Dale La Forest & Associates  
Design, Planning & Environmental Consulting  
101 E. Alma Street, Suite 100-A  
Mt. Shasta, CA 96067  
(530) 918-8625

SYAR NAPA QUARRY EXPANSION PROJECT - Napa County  
Comments on Environmental Impact Report  
**PROJECT'S SIGNIFICANT NOISE IMPACTS**

**Comment Letter #3**  
**REPLIES TO RESPONSE TO COMMENTS**  
**IN GHD's Oct. 15, 2015 Memorandum**

This photo shows that the Napa State Hospital has second floor patient rooms with windows that are higher above the ground than the top of exterior courtyard walls.

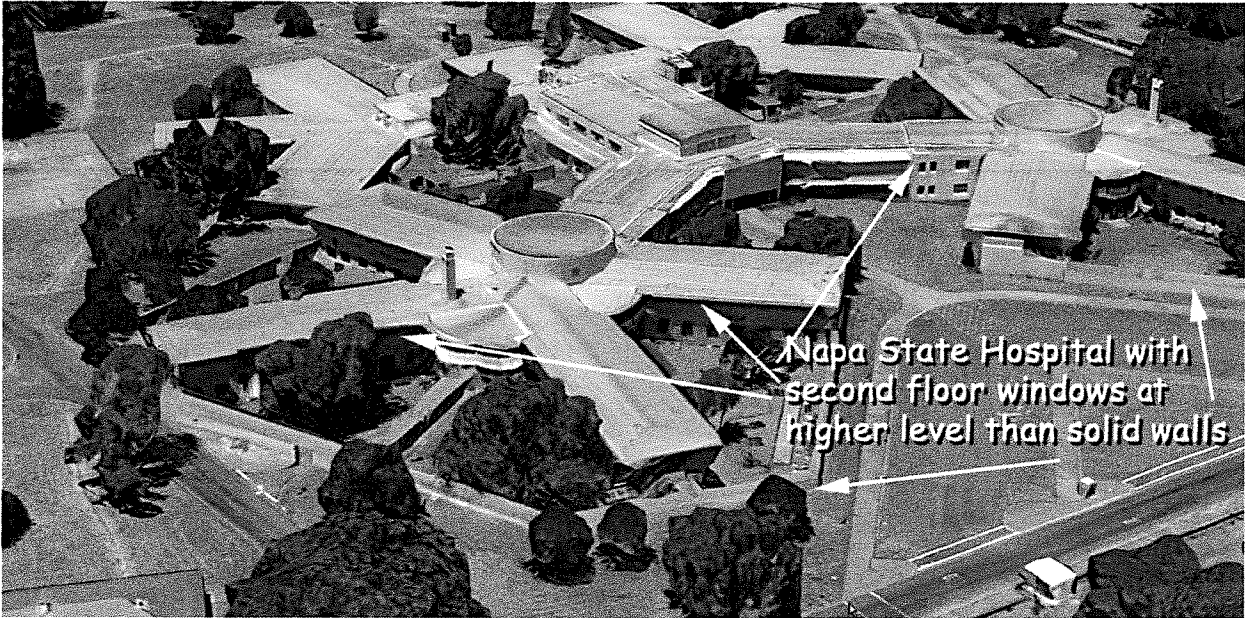
Here is some photographic evidence that no such barriers will block any direct line of sight to some patient rooms. This angle of view in the next photo is higher than as seen from Syar's proposed unshielded quarry's upper edge. But it shows that the walls are interrupted with chainlink gates and are not tall enough to offer barrier noise protection.

As these somewhat fuzzy photos from Google Maps reveal, there are second story windows here. GHD's Response to Comments ignores that some patient rooms at the Napa State Hospital are on the second story with windows facing uphill to Syar's proposed expanded quarry excavation areas along the ridgeline. Second floor windows are higher than any 10-foot high wall and would not experience any such noise reduction. GHD is simply wrong in its Response to assume a 5-dB noise level barrier reduction for those second-story patient rooms.

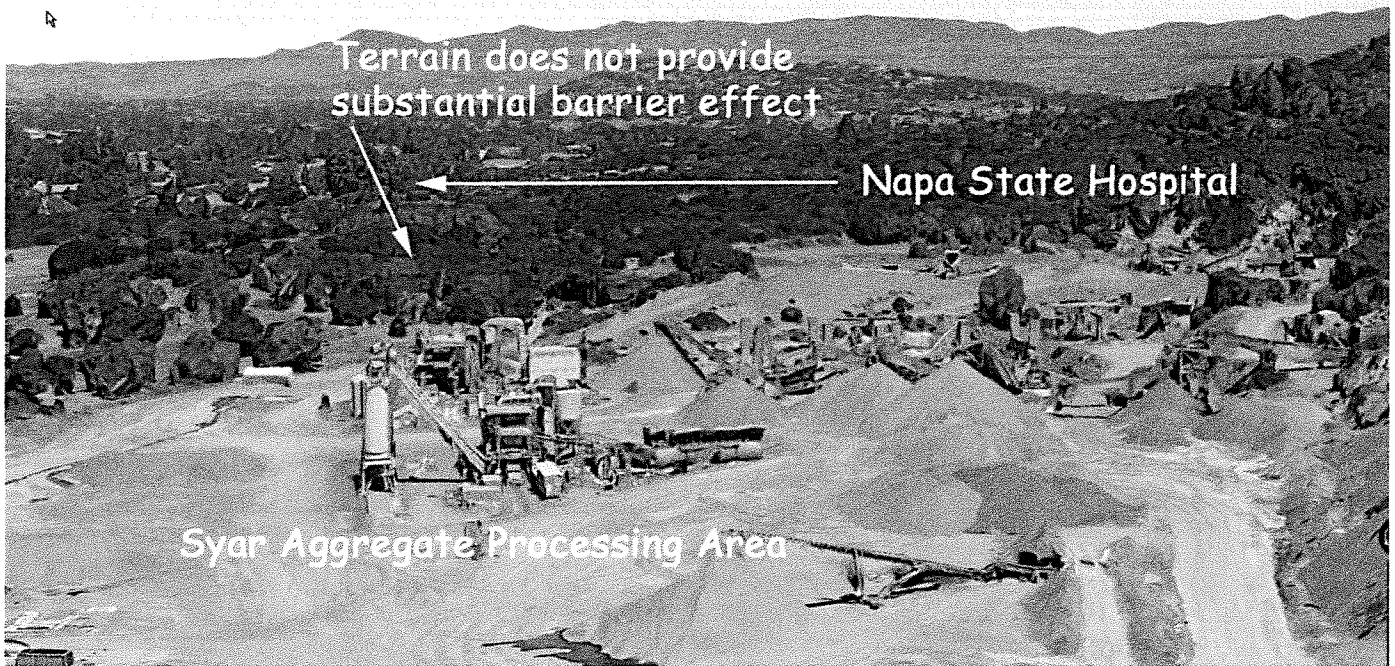
**GHD's Response states that there is no direct line-of-sight from receptors at the Napa State Hospital to Syar's processing areas to the south due to intervening terrain, as if to imply that no noise from processing operations reaches this Hospital's receptors.**

GHD provides no maps, cross section drawings, or noise level measurements to support that Response. GHD presented no noise level measurements near this Hospital of existing quarry operations, either in the DEIR or now. GHD also provides no scientific information to demonstrate that noise from distant expanded quarry operations will be

View looking North from Quarry Processing Area

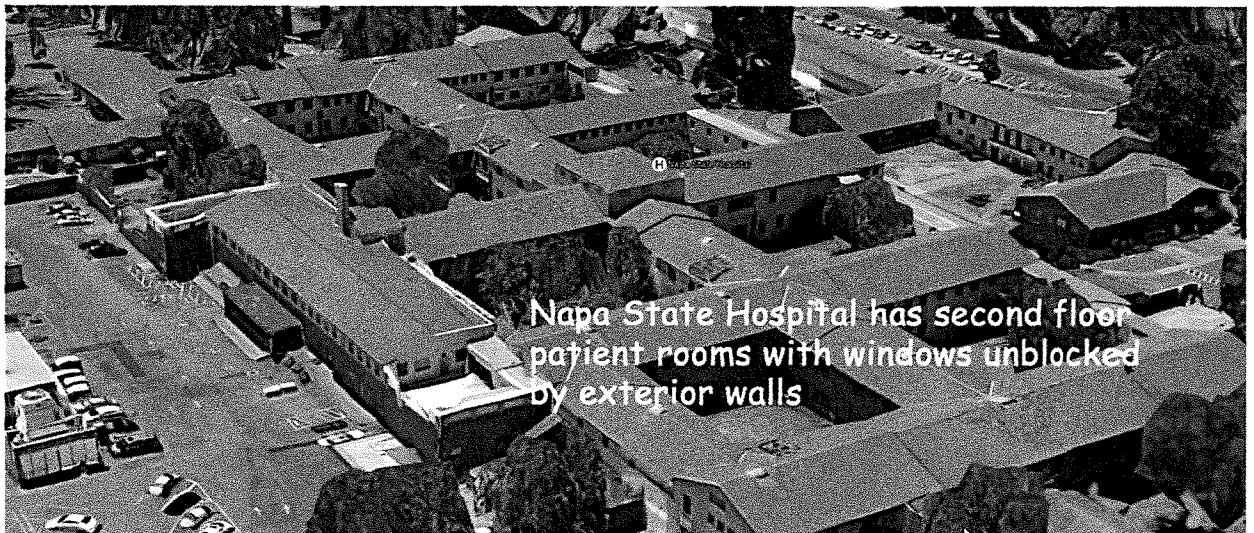
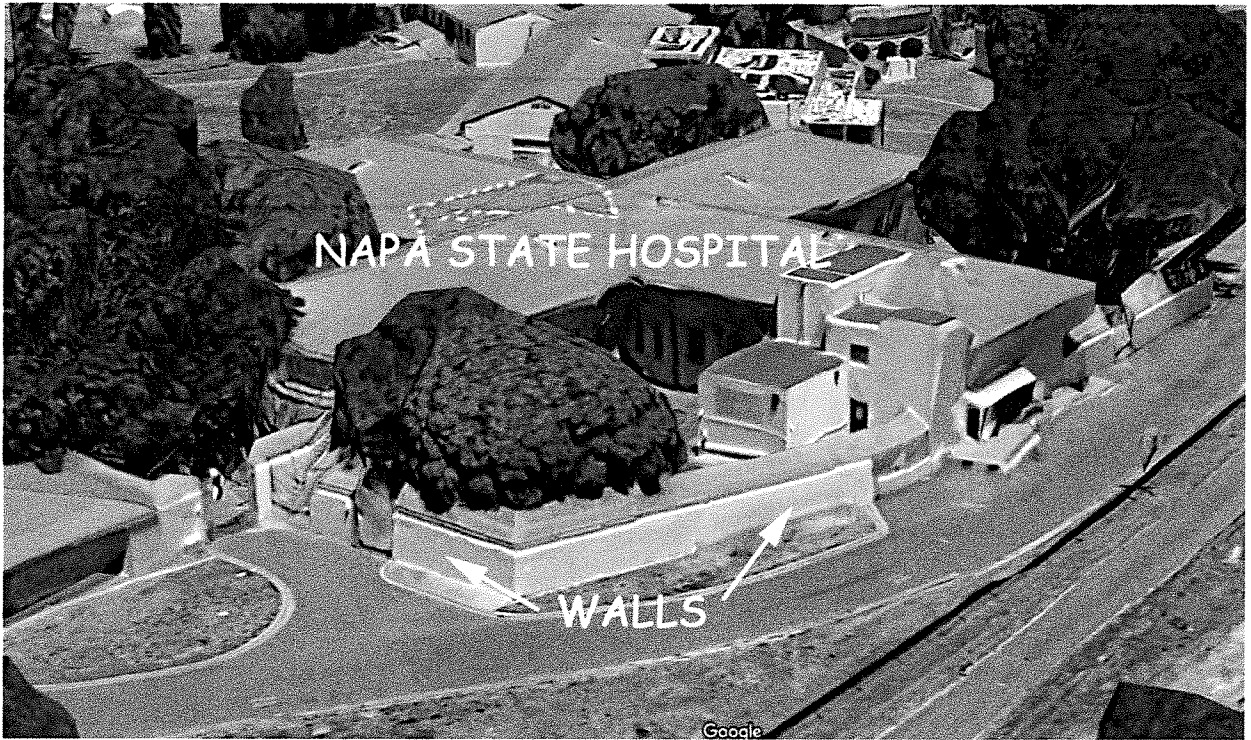
**GHD's Response states that receptors will be shielded from noise during excavation of the westernmost section of the State Grey pit is mined due to 10-foot high masonry walls having a minimum of 5 dBA of acoustical shielding.**

No such noise barrier attenuation will occur in these particular circumstances. Sources of quarry excavation noise up at that ridgeline would have a direct line-of-sight view at a downward angle in the direction of the Hospital. That line-of-sight passes over the top of the masonry walls directly hitting even the lower first floor patient windows. Line-of-sight from many east-facing windows to the quarry ridgeline is not interrupted by a solid wall. For those second floor and even first floor rooms, there also would be no noise level reduction due to a 10-foot solid wall barrier as GHD claims.

GHD's Response is not even consistent. Previously GHD argued that 10-foot high walls provide 13 dBA of attenuation. Then GHD predicts that shielding will reduce noise levels by 5 dBA. In neither case does GHD provide any math or substantial evidence to justify such a noise barrier attenuation assumption. In fact, quarry noise from unshielded overburden removal and initial excavation at the quarry's upper edge will not be effectively reduced when exposed to some Hospital windows by such solid courtyard walls.

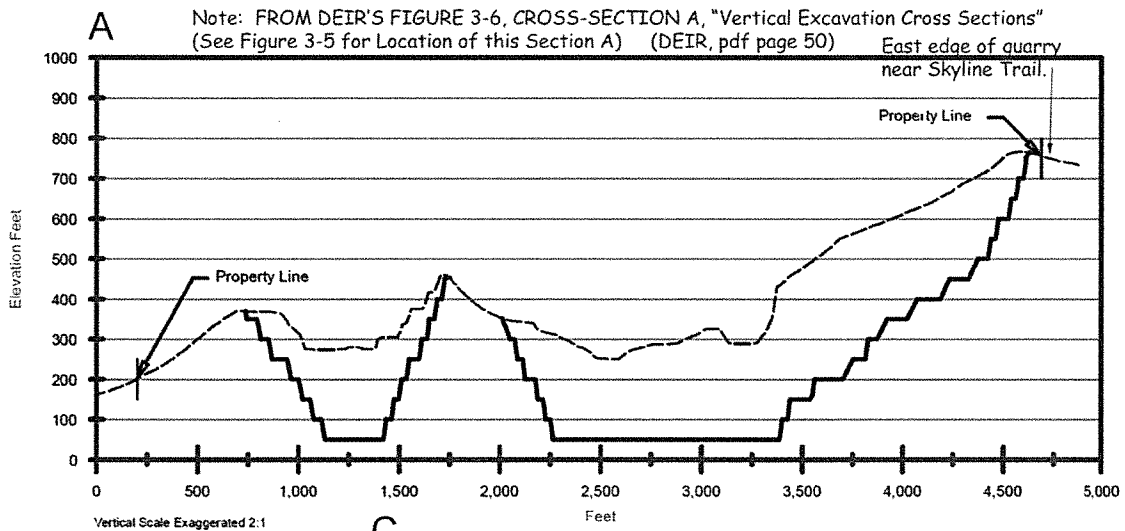
**GHD Responds that a complete description of mining noise heard at trails in the Skyline Wilderness Park is disclosed in the FEIR. Cross Section drawings show that park users will not have direct line-of-sight to long-term mining activities. The comment ignores intervening topography. The noise level at the receptor will be an acceptable 46 dBA L<sub>50</sub>. Mitigation will achieve County noise level standards of 50 dBA L<sub>50</sub> or less. All quarry activities will be shielded by intervening terrain at established trail locations.**

- a) Such descriptions of mining noise should legally have been first provided in the DEIR so the public could have reviewed that new information.
- b) GHD never demonstrated that intervening terrain would have the noise attenuation effect GHD claims, either theoretically or with actual noise level measurements of representative equipment operating at the proposed ridgeline areas.

**DEIR, Figure 3-6, CROSS SECTION A - See Enlargement Below of Upper Right**  
*(Text notes in blue ink below are comments, not a part of the original Figure 3-6.)*

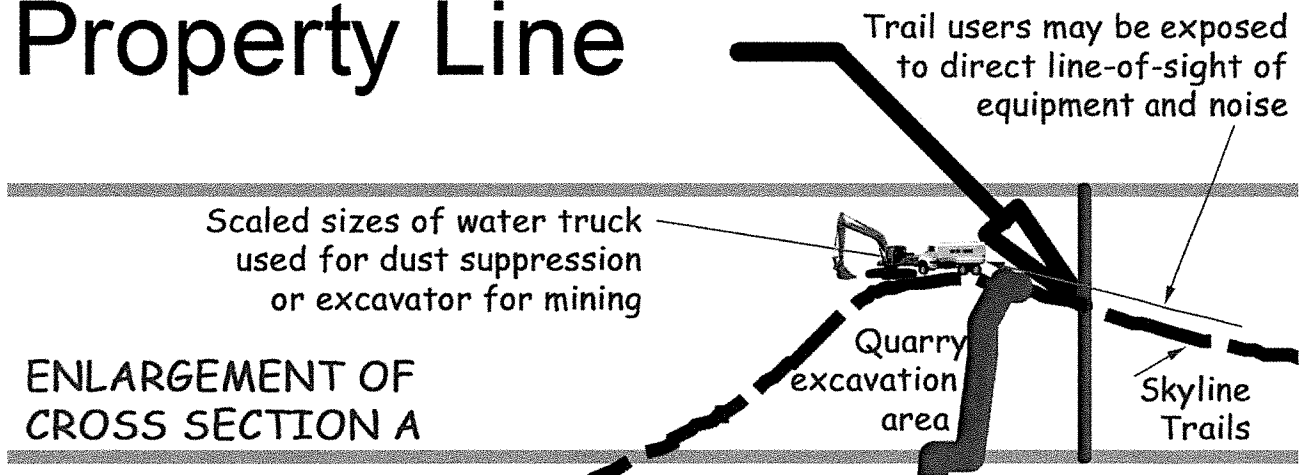
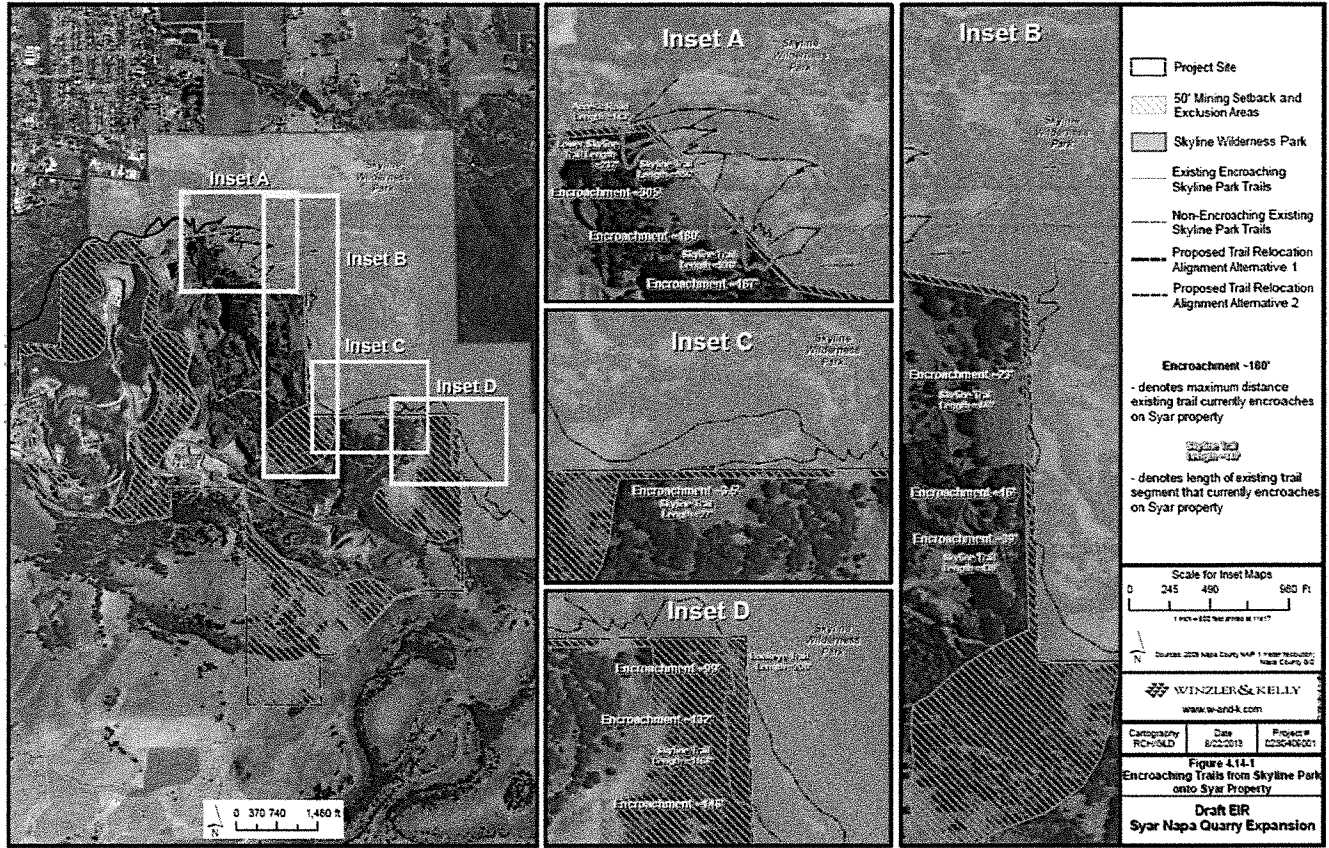
DEIR is accurate. Figure 3-6, Cross section A shows that the upper western edge of land in the quarry will be excavated and will at least for weeks be in direct line-of-sight of Skyline Wilderness Park to the east with no intervening topographic barrier effect. (See drawings below)

- i) The DEIR fails to contain any maps that are merged in one place and show existing trails and the vicinity's topography. That lack of important information makes it very difficult for the public to understand which existing trails might be exposed to Syar's unshielded overburden removal activity noise. The DEIR is inconsistent with CEQA's objectives to provide such clear and understandable analysis to the public. However, it appears that from viewing Figure 3-6, Cross Section A, and Figure 14.1, Inset B, that the Skyline Trail along the east side of the quarry will have direct line-of-sight views to the unshielded overburden removal and initial excavation at the quarry's upper edge.
